CITY of NOVI CITY COUNCIL

Agenda Item 1 November 13, 2018

SUBJECT: Consideration for tentative approval of the request of Erhard Motor Sales, Inc., for a Special Development Option (SDO) Concept Plan in the GE, Gateway East District. The subject property is 9.48 acres of land located at the southwest corner of Grand River Avenue and Meadowbrook Road, in Section 23. The applicant is proposing a 58,663 square foot car sales facility for Jaguar Land Rover.

REVISED PHOTOMETRIC PLAN
Submitted Via E-mail: 10-29-18

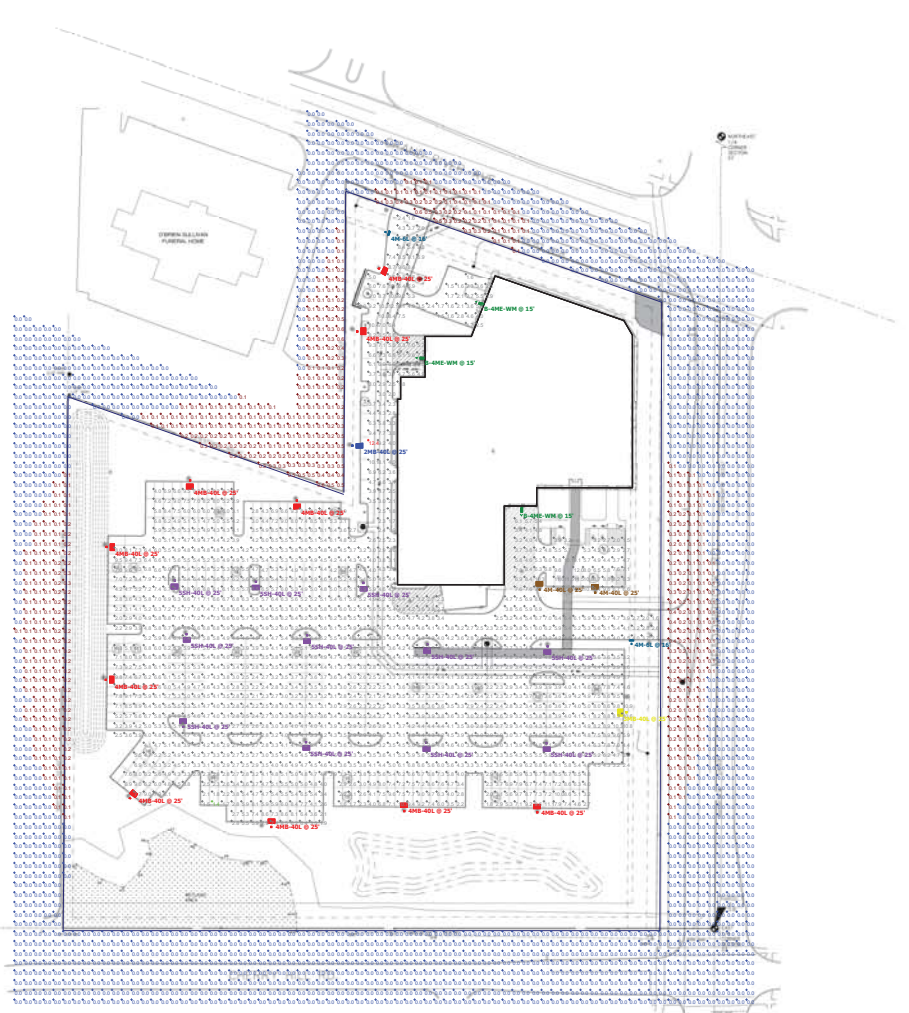
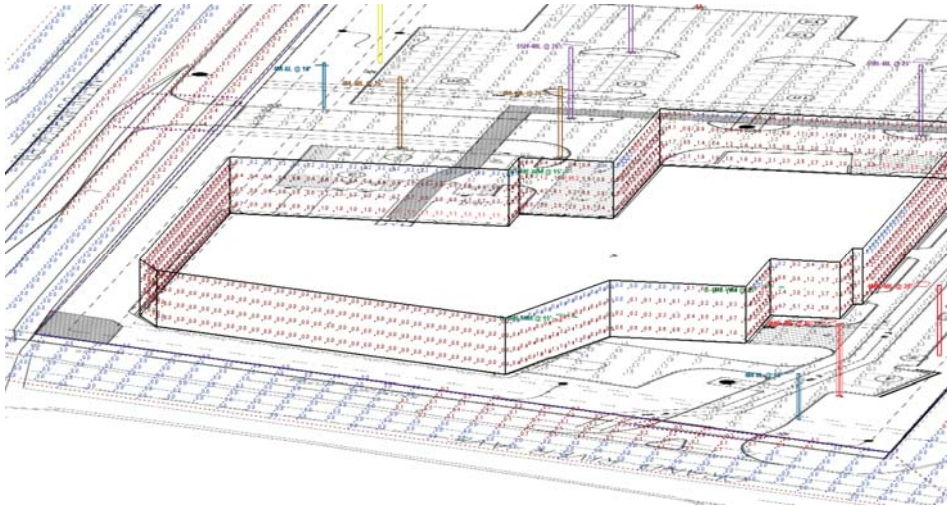
Staff has requested a photometric plan to verify the illumination levels at the property line due to its proximity to residential areas. The applicant has provided a photometric plan (attached) that indicates the illumination levels less than the maximum of 0.5 foot candles at the property line, which meets the ordinance requirements.

ORIGINAL ISSUE DATE: AUGUST 6, 2018
PEA JOB NO. 2017-176
SCALE:
DRAWING NUMBER:
SP-2.0

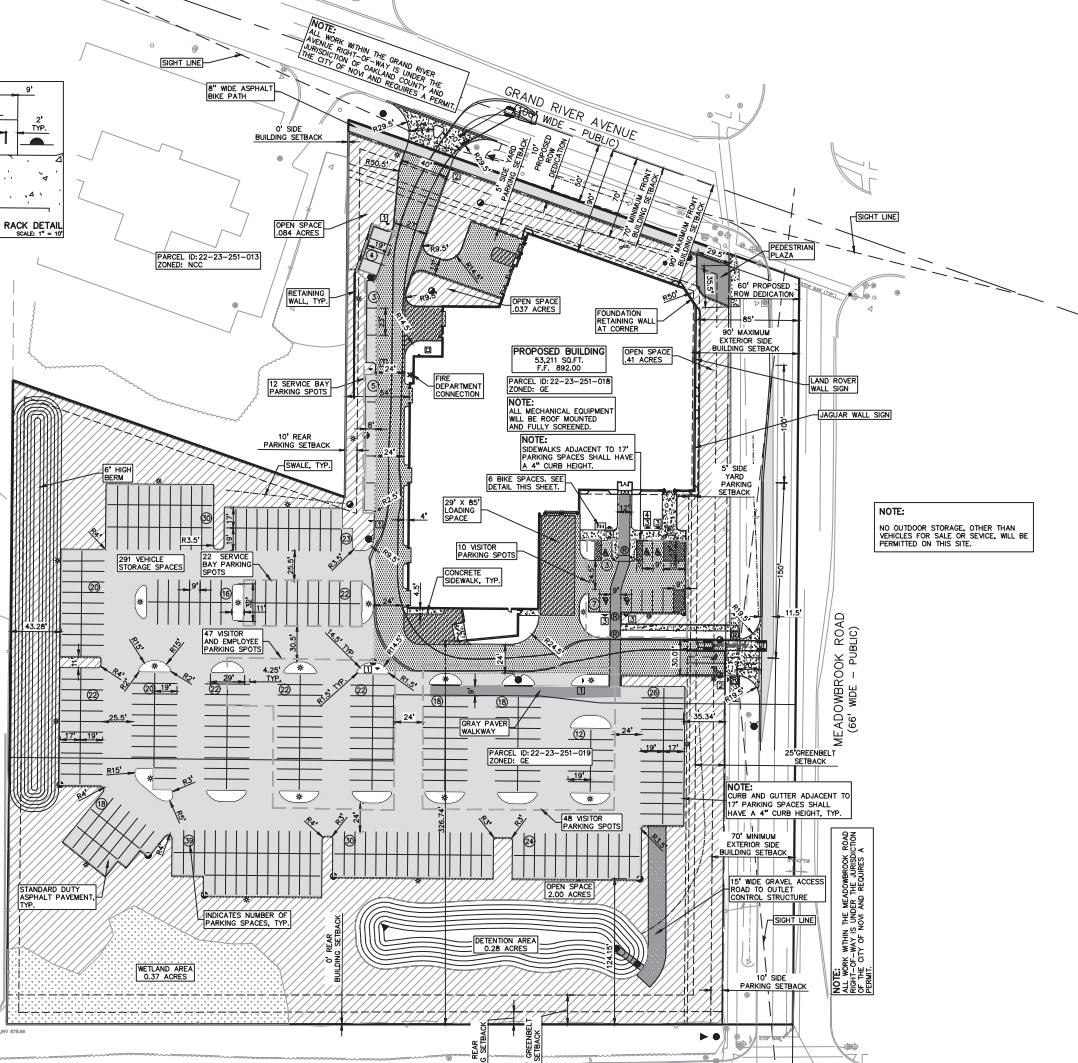
- f. The applicant is required to provide two (2) bicycle parking spaces for the service center section of the development and six (6) have been provided. A bicycle parking layout is shown on sheet SP-2.0 but a dimension for the width of the sidewalk should also be included.

- f. **The applicant is required to provide two (2) bicycle parking spaces for the service center section of the development and six (6) have been provided. A bicycle parking layout is shown on sheet SP-2.0 but a dimension for the width of the sidewalk should also be included.**

Updated calculations demonstrating compliance with the Open Space requirements will be added to sheet SP-2.0.

Bike racks will be relocated to limit the number of racks at any one entrance on sheet SP-2.0.

Additional calculations will be added to SP-2.0 to demonstrate conformance with open space requirements.

Corner clearance zones will be added to SP-2.0 to the next resubmittal.

ORIGINAL ISSUE DATE: AUGUST 6, 2018
PEA JOB NO. 2017-176
SCALE: 1" = 50'
DRAWING NUMBER: L-1.0

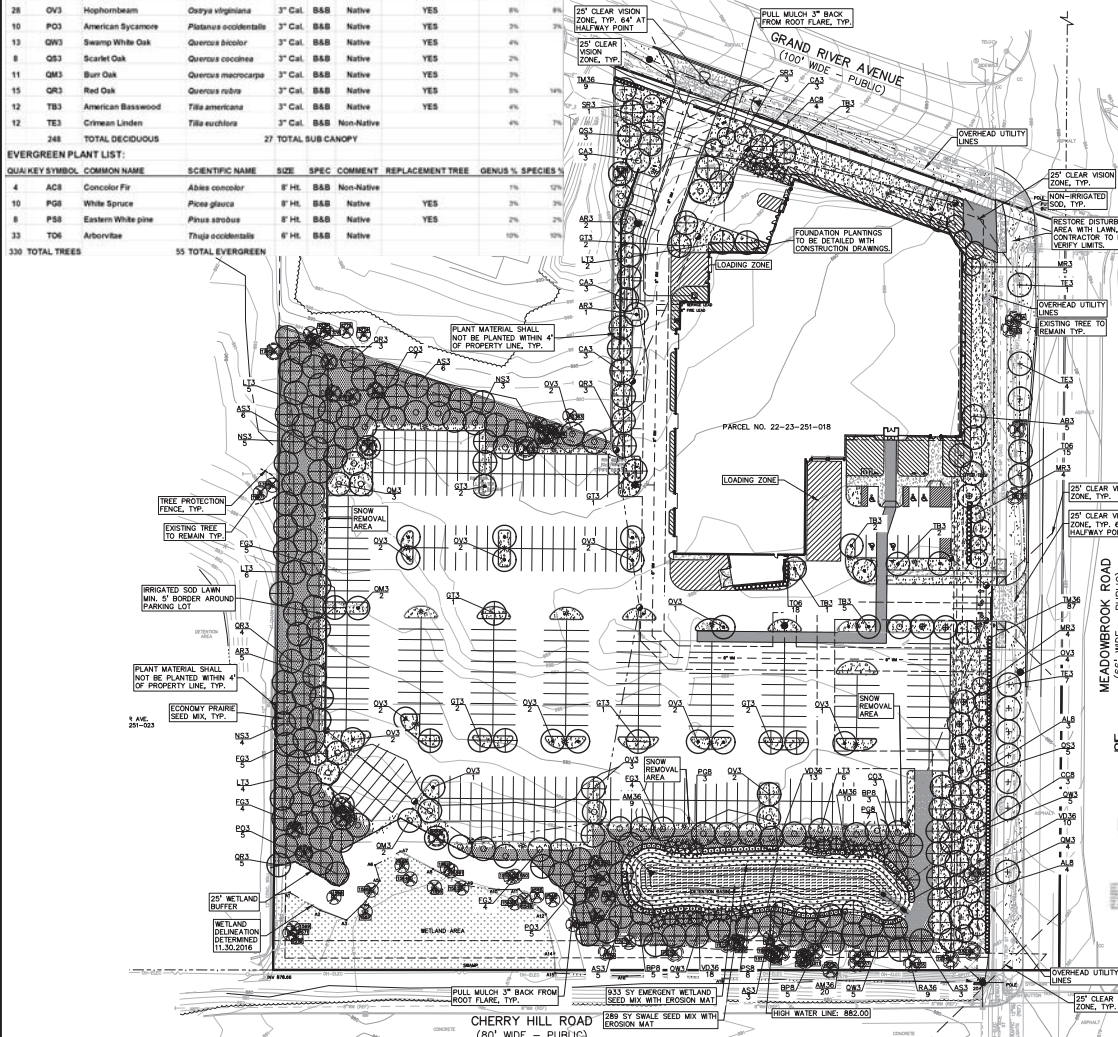
The Woodlands review notes the applicant proposes removal of 48 percent of the trees surveyed: 149 trees are proposed to be removed of the 310 trees surveyed. The concept plan proposes to plant 172 trees on site. The Woodland Replacement trees are proposed around the storm water detention basin, along the west edge of the property, near the loading zone, and within several parking lot islands. The location of the trees in the parking lot islands and perhaps near the loading zone is not consistent with the intent of the Woodland Ordinance in mitigating for the loss of woodland tree canopy. The applicant has agreed to relocate the trees out of the parking lot with the next plan submittal.

DRAWING NUMBER:
T-1.0

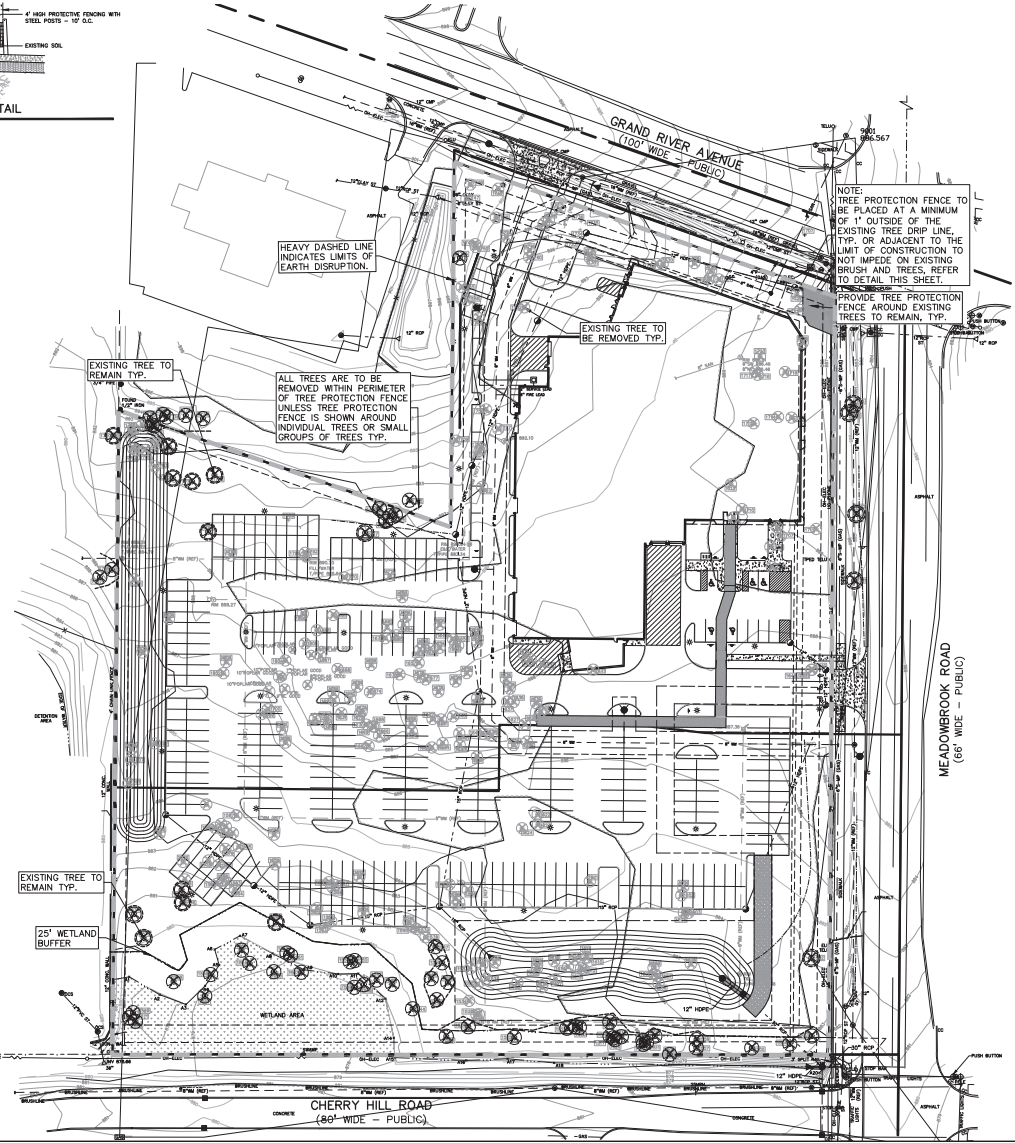
The Plan includes a *Tree Plant List* on Sheet T-1.0, that lists the species of the proposed Woodland Replacement Trees; however it does not currently appear to specify the quantity of each species that will be used as Woodland Replacement tree credits. The applicant should, for example, specify how many of the 28 hophornbeam listed in the list are Woodland Replacement Trees as opposed to Perimeter Parking Lot or Landscape trees, etc. All of the tree species proposed as Woodland Replacement Tree material appears to be acceptable per the City's Woodland Tree Replacement Chart, however, the applicant shall specify the thornless honeylocust (*Gleditsia triacanthos inermis*) on the Plan.

2. The Plan includes a *Tree Plant List* on Sheet T-1.0, that lists the species of the proposed Woodland Replacement Trees; however it does not currently appear to specify the quantity of each species that will be used as Woodland Replacement tree credits. The applicant should, for example, specify how many of the 28 hophornbeam listed in the list are Woodland Replacement Trees as opposed to Perimeter Parking Lot or Landscape trees, etc.

- 2. The Plan includes a Tree Plant List on Sheet T-1.0, that lists the species of the proposed Woodland Replacement Trees; however, it does not currently appear to specify the quantity of each species that will be used as Woodland Replacement tree credits. The applicant should, for example, specify how many of the 28 hophornbeam listed in the list are Woodland Replacement Trees as opposed to Perimeter Parking Lot or Landscape trees, etc.**
